Groundwater Transfer Review Summary Form

Transfer/PA # T- 14912

Application: T-14912

Applicant Name: Strata Land Holdings LLC

Theis distance-drawdown/interference estimate: existing POA (CLAC 5484) to CLAC 5573**Theis Time-Drawdown Worksheet** v.5.00

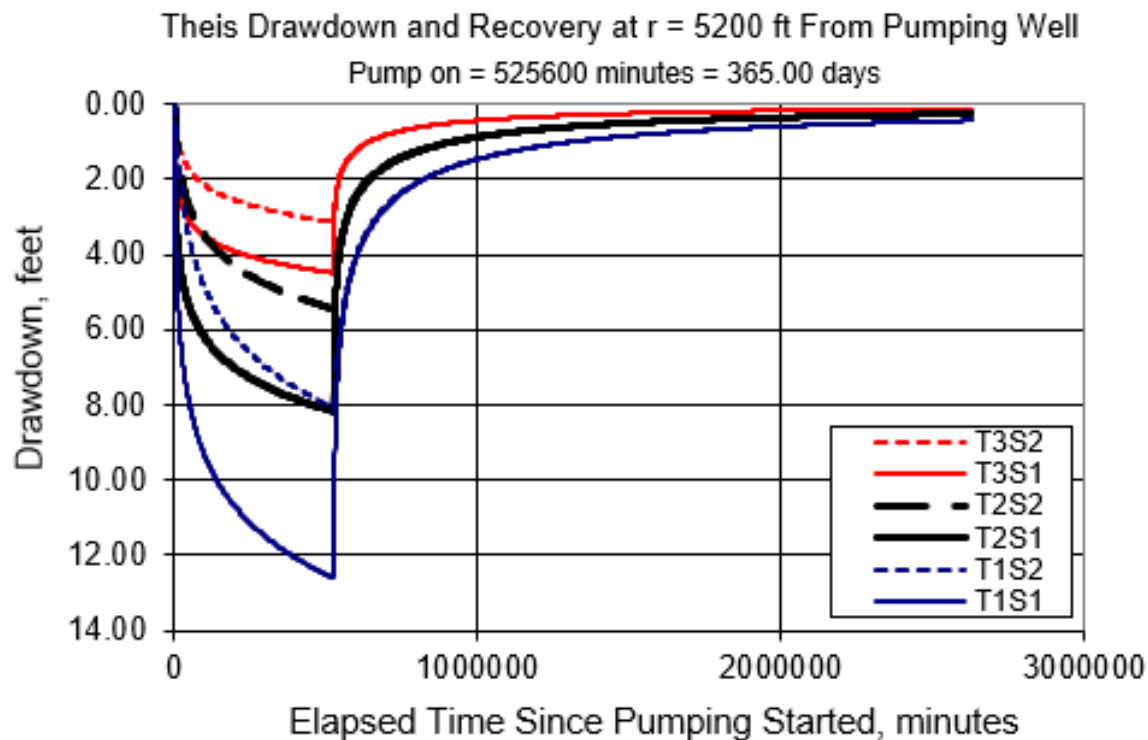
The Theis distance-drawdown analytical equation was used to evaluate interference at CLAC 5573 due to pumping at the proposed POA (CLAC 5617) location (Theis, 1940). Using aquifer parameters derived from local pumping test results and very conservative operational parameters (pumping 24/7/365 at 0.56 cfs (~250 gpm)), the additional net drawdown expected at CLAC 5573 (compared to similar pumping of CLAC 5484) ranges from approximately 2 to 4 feet (see attached Theis analytical results). Recent measurements in CLAC 5573 indicate there is about 40 feet of available drawdown in CLAC 5573 before the pumping water level reaches the perforated section of the well. Thus this amount of additional interference (2-4 feet), derived using very conservative operational parameters, is not likely to result in CLAC 5573 or other similarly-located groundwater rights from receiving the water to which they are legally entitled.
